ADDENDUM NO. 4

Rochester City School District

Dr. Walter Cooper, School #10

March 9th, 2018

AD4-A001

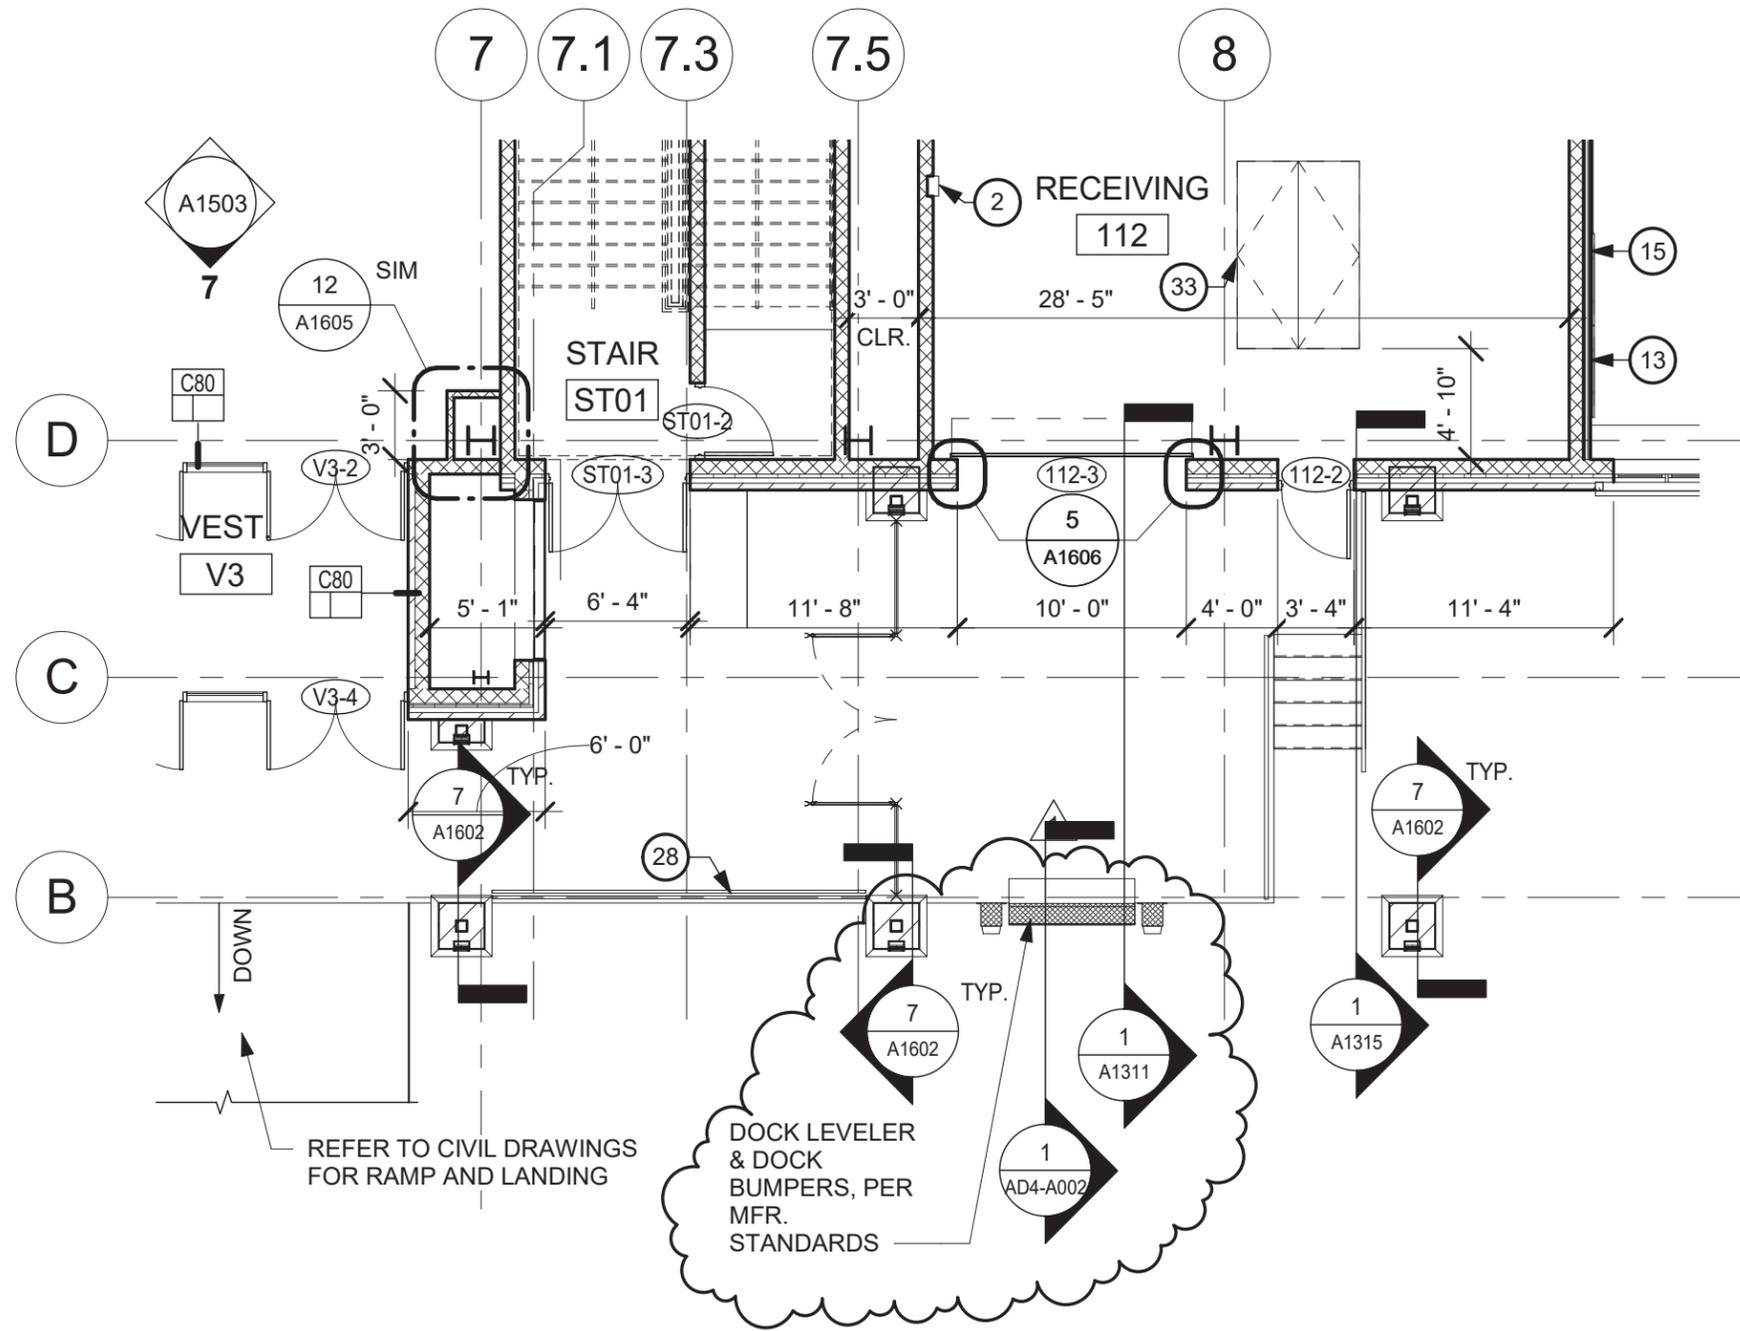
Item AD4-22 **ADD** the attached sketch “AD4-A001 – PARTIAL PLAN OF LOADING DOCK.” Revised details at dock leveler.

1 03/09/18 ADDED DOCK LEVELER

AD4-A002

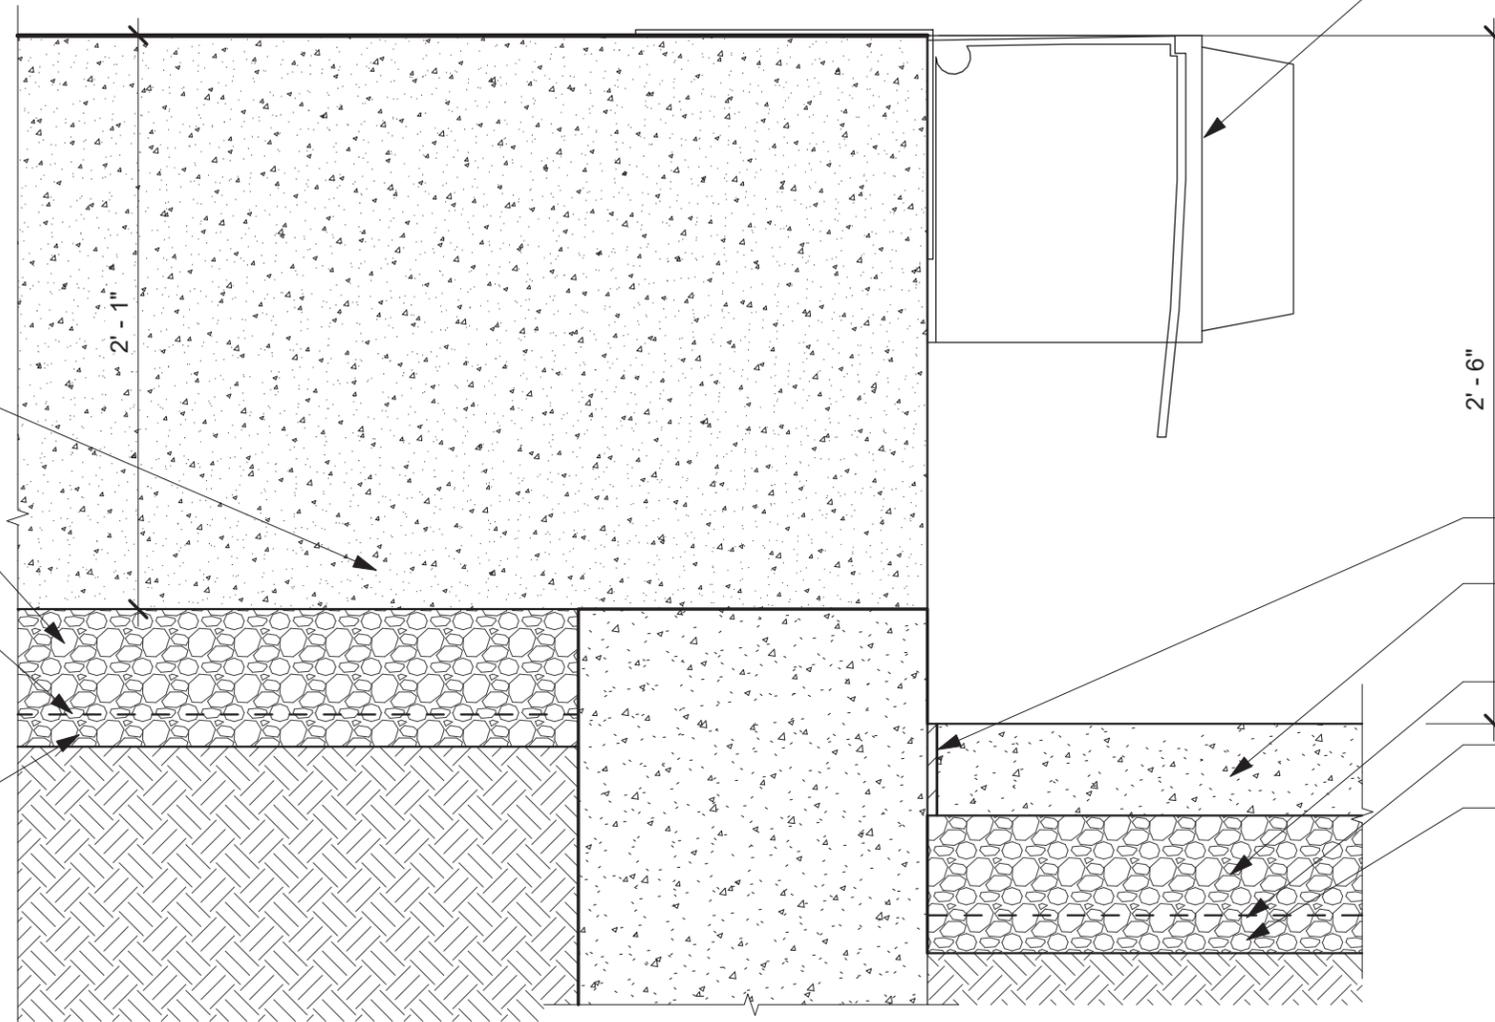
Item AD4-40 **REPLACE** drawing 5/A1601 with the attached sketch “AD4-A002 – SECTION AT DOCK LEVELER.”

AD4-A003

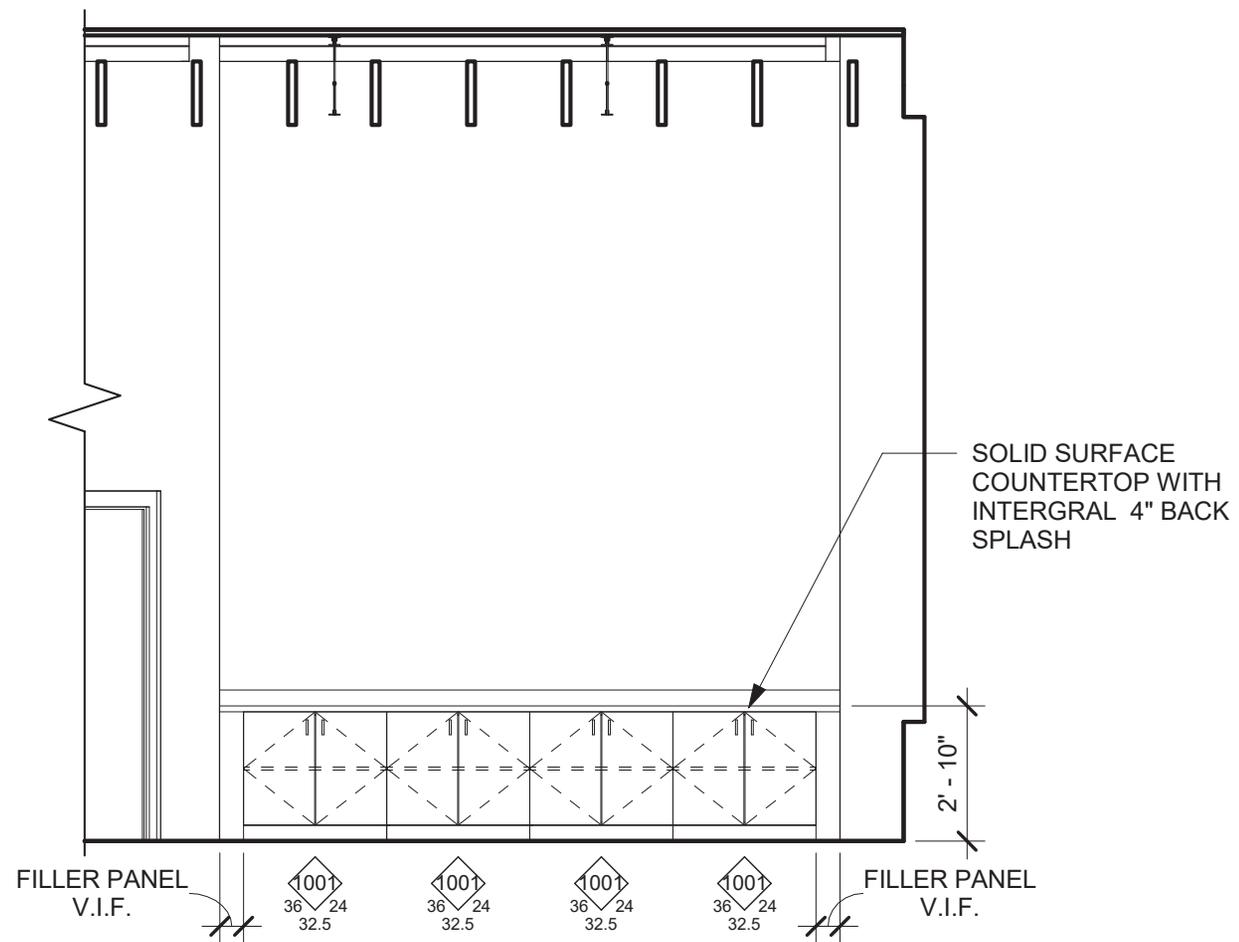
Item AD4-37 **REPLACE** drawing 5/A1503 with the attached sketch “AD4-A003 – INTERIOR ELEVATION.”

AD4-P001

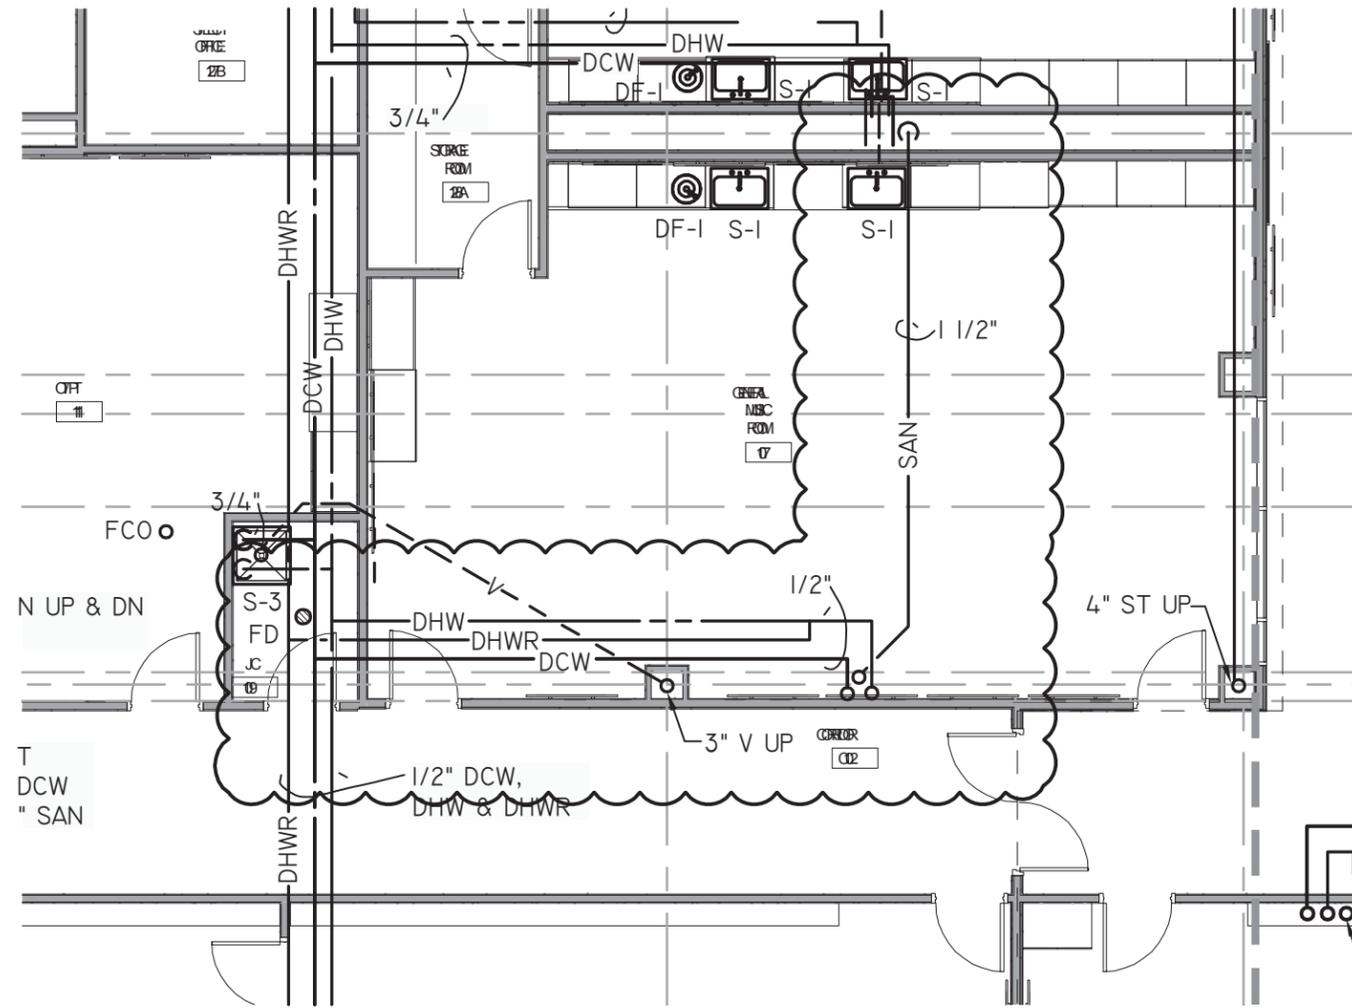
Item AD4-43 **ADD** the attached sketch “AD4-PO01 – PLUMBING REVISION” to drawing P1102.

Item AD4-44 **DELETE** reference to floor drain in storage room 115A and all associated piping.

AD4-P002

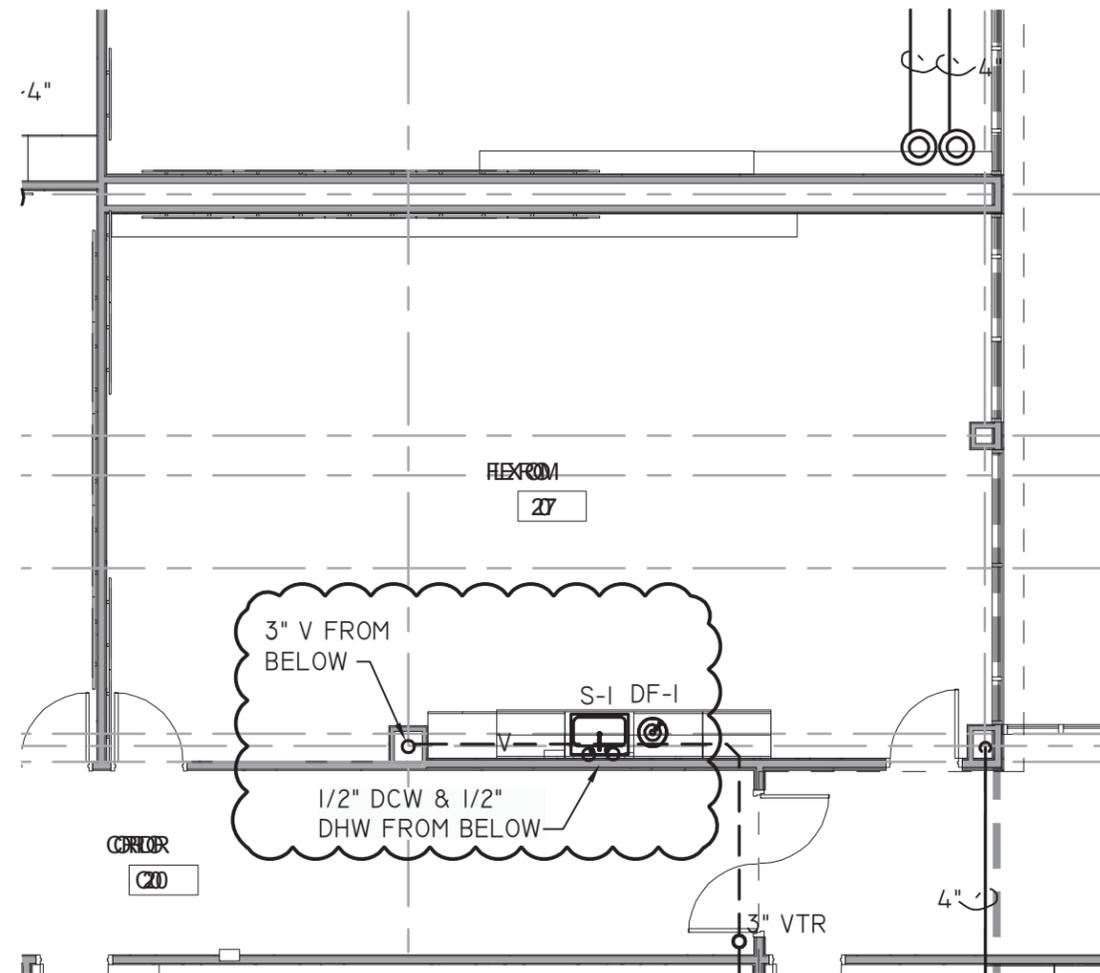
Item AD4-45 **ADD** the attached sketch “AD4-PO02 – PLUMBING REVISION” to drawing P1104.
